Date: 15 September 2026
Council Ref: A006830995

**RE: MINOR CHANGE TO A DEVELOPMENT APPROVAL
DEVELOPMENT PERMIT FOR A MATERIAL CHANGE OF USE FOR MULTIPLE DWELLING
23 CREMIN STREET, UPPER MOUNT GRAVATT QLD 4122**

Figure 1 –Ground Floor Plan comparison

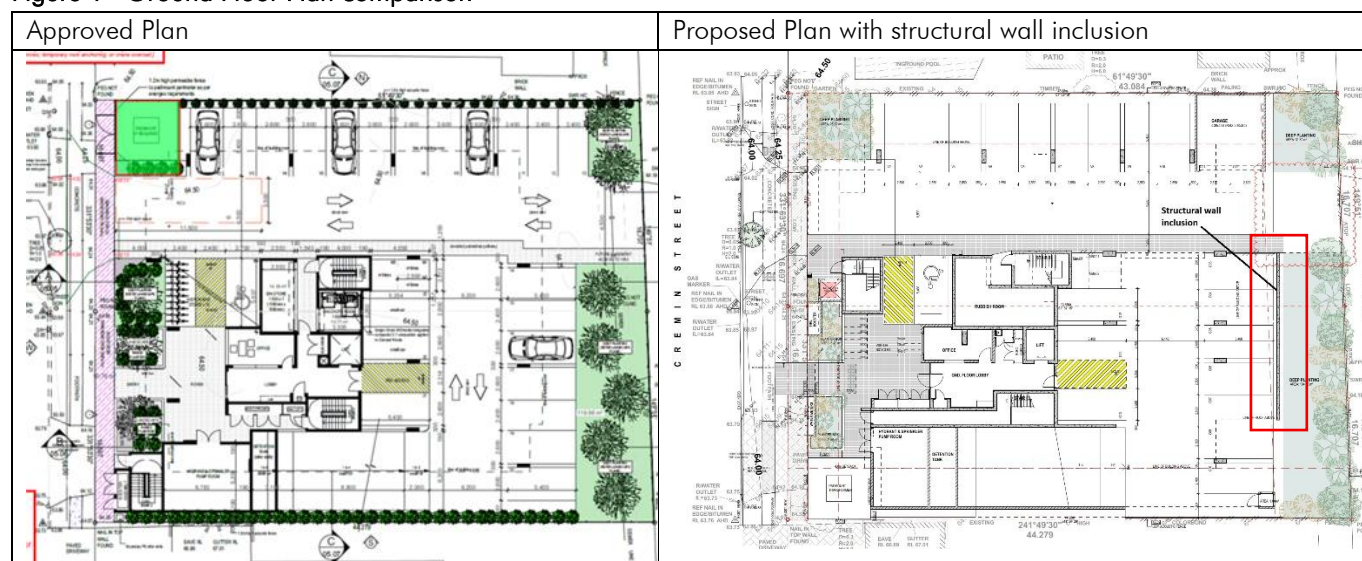
The proposed Ground floor plan incorporates new structural columns to align with the building design. This is evident adjoining the internal access, vehicular ramp and resident car parking. As illustrated in **Figure 1**, the proposal incorporates an additional structural wall to the rear of car park G03 to G07, noting the wall does not

fundamentally impact on the ability of the deep planting area to accommodate a minimum dimension of 4m, and large subtropical shade tree species yet has a marginal difference in overall width.

Figure 4 - Comparison floor plan changes

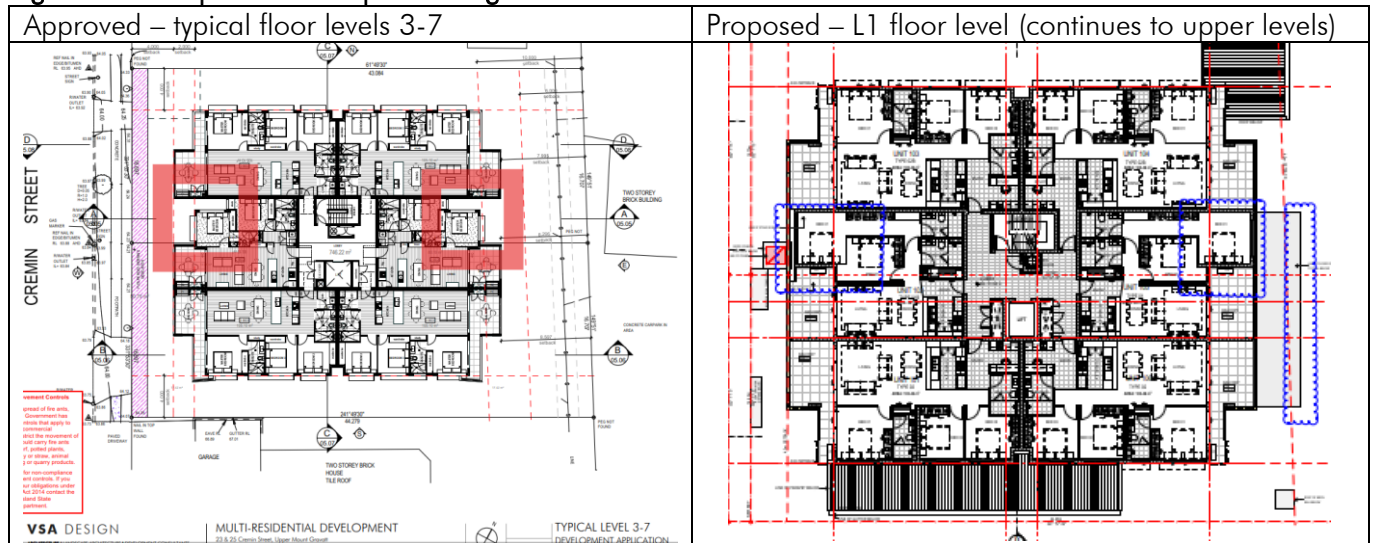
The proposal features a slight increase in site cover to 54.4%, which is experienced within the building footprint, as opposed for extending outwards – Refer comparison of typical floor plans in **Figure 4**. In reviewing the existing approved Multiple Dwelling plans, it is evident the building setbacks remain principally the same to the front balconies, rear boundary and side boundaries where a setback of 4m is applied. The Minor Change Plans in **Attachment A** incorporate a redesign of the two-bedroom apartments which have been increased to a spacious internal area of 86.2m². There are no overall changes to the unit typology, private open space, or configuration with three-bedroom dwellings to the exterior.

Figure 5 – Proposed frontage changes

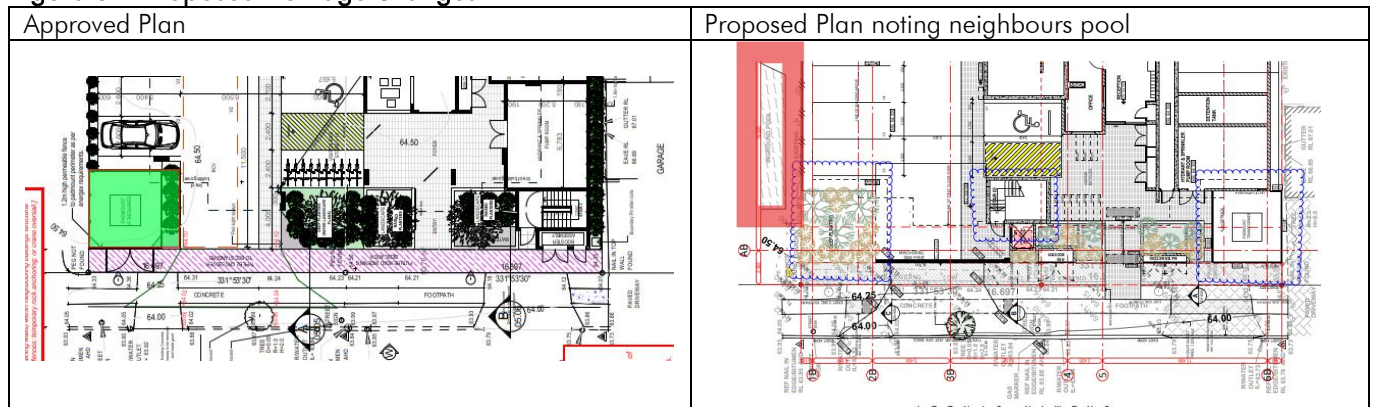
The proposed plans incorporate several changes to the Deep Planting design to Cremin Street. As illustrated in **Figure 5** below, the site's north-western corner now accommodates a 25.82m² area for deep planting, with the previous front strip now identified for smaller plant species adjoining the visitor bicycle parking. Under Energex regulations, the padmount transformer could be located within 10m of an in-ground pool. The neighbouring premises at 27 Cremin Street is currently located within the front boundary necessitating the rearrangement of these areas.
